[Docket No. FAA-2023-1650; Project Identifier AD-2023-00795-T; Amendment 39-22517; AD 2023-15-05]

#### Airworthiness Directives; The Boeing Company Airplanes

**ACTION:** Final rule; request for comments.

**Figure 1 to paragraph (g) - Engine anti-ice AFM revision**

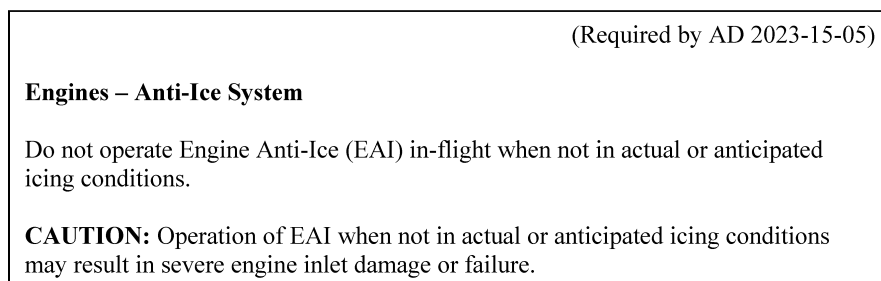
Within 15 days after the effective date of this AD: Revise the Limitations Section of the existing AFM to include the information specified in figure 1 to paragraph (g) of this AD. This may be done by inserting a copy of figure 1 to paragraph (g) of this AD into the existing AFM.
